June 1, 2005

Mr. Loren Meinz
Albuquerque Metropolitan Arroyo
Flood Control Authority
2600 Prospect Avenue NE
Albuquerque, New Mexico 87101

Re: Review of Proposed Juan Tabo Boulevard Crossing of Tijeras Arroyo

TITLE: JUAN TABO BOULEVARD S.E. - PHASE II
GUIDE BANK PLAN

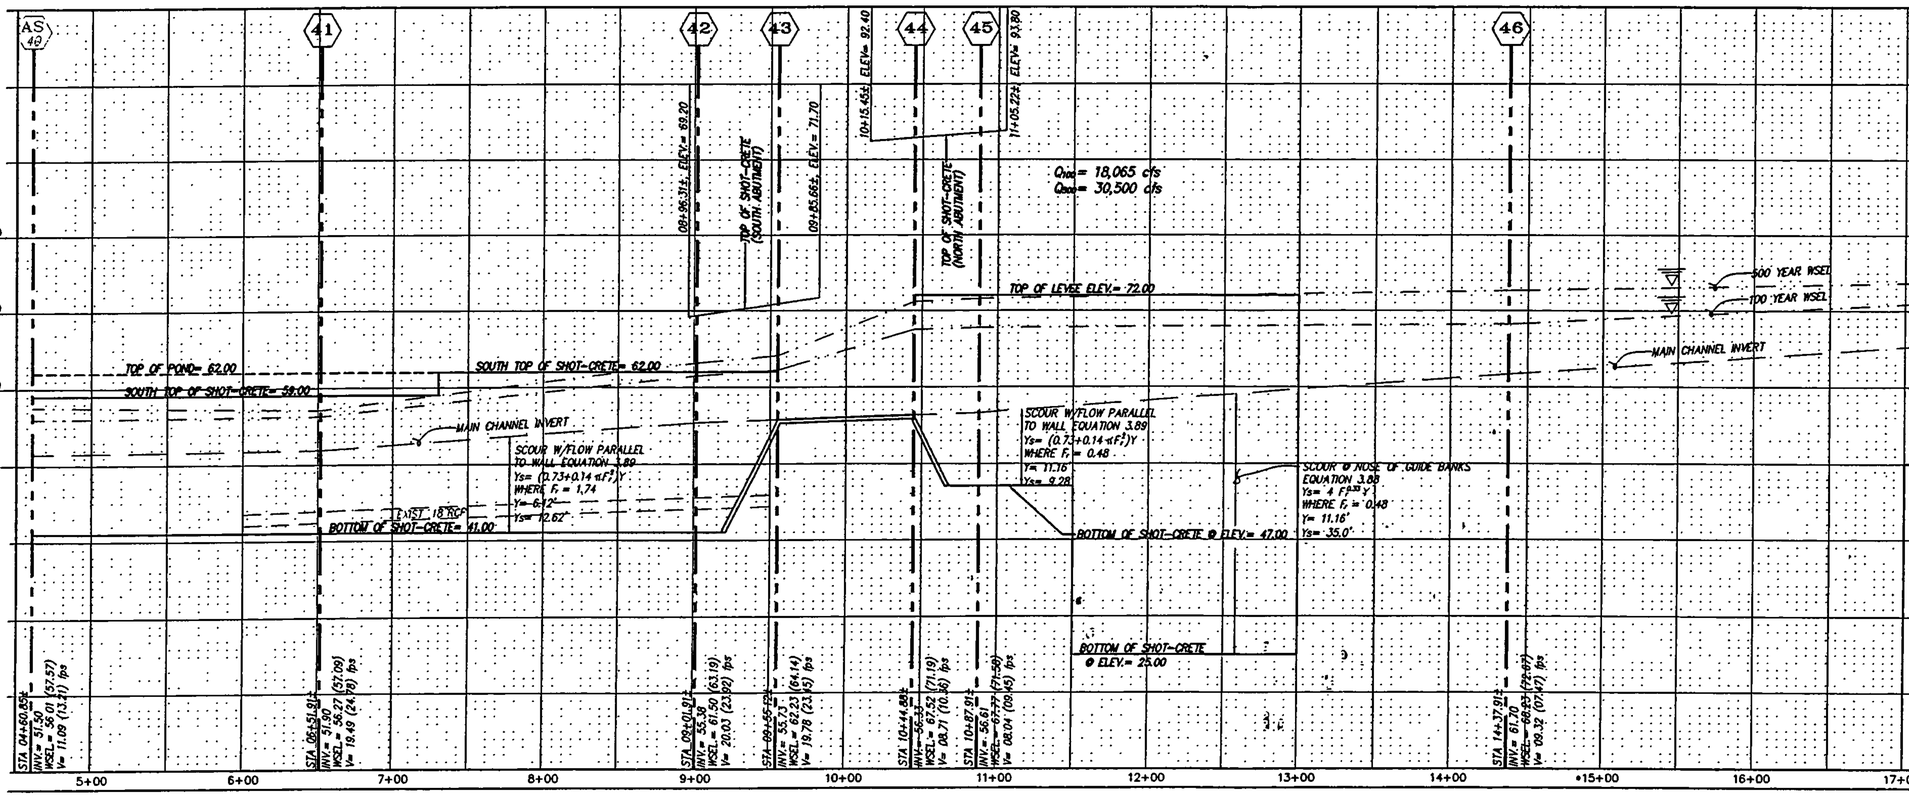
4. Inundation limits are shown both on the work map in the report and on sheets 3 & 8 of the construction plans.
